URBAN DESIGN REVIEW BOARD

STAFF REPORT

UDRB Hearing Date: October 20, 2023

Site Address: 803, 805, 829, 837, 845, 847, 861 Main Street.

ELEVATIONS

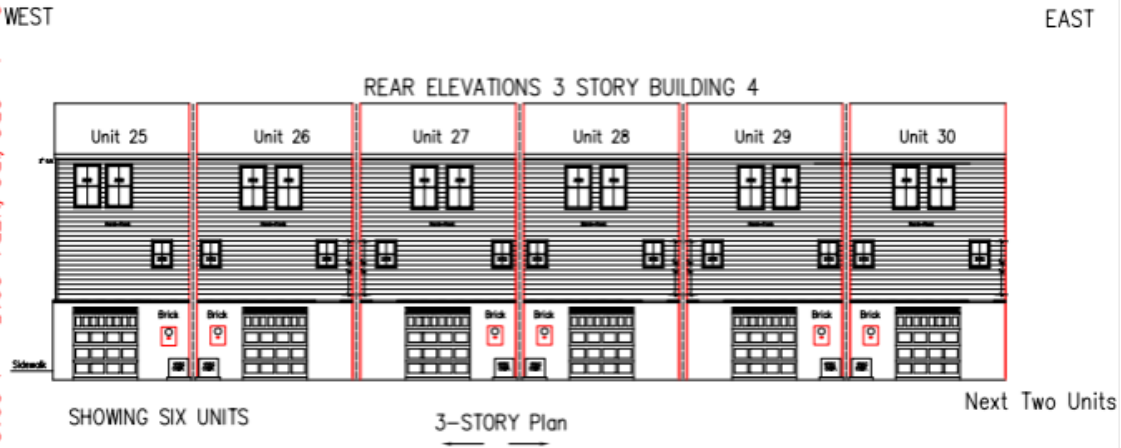
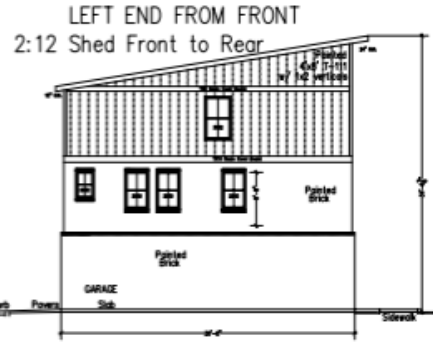
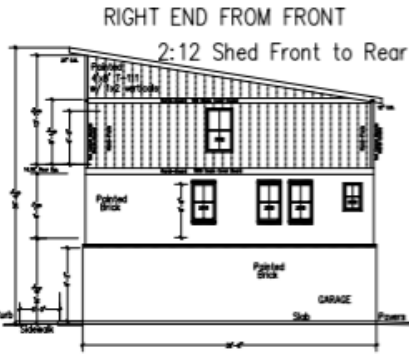
1. Include an additional type of metal awning/canopy to complement the eyebrow arch to further provide a difference in appearance of each unit.
2. Take away one of the windows and provide a backdoor on the main living/dining area in the rear of buildings above the garage to give owners an option to build a deck for additional living space in the future if they desire.
3. The roof should be shingled.
4. Include wrought iron 4 ft. fence in front of buildings with gate access so that each unit can have a small space, may need to adjust the direction of the front porch steps.
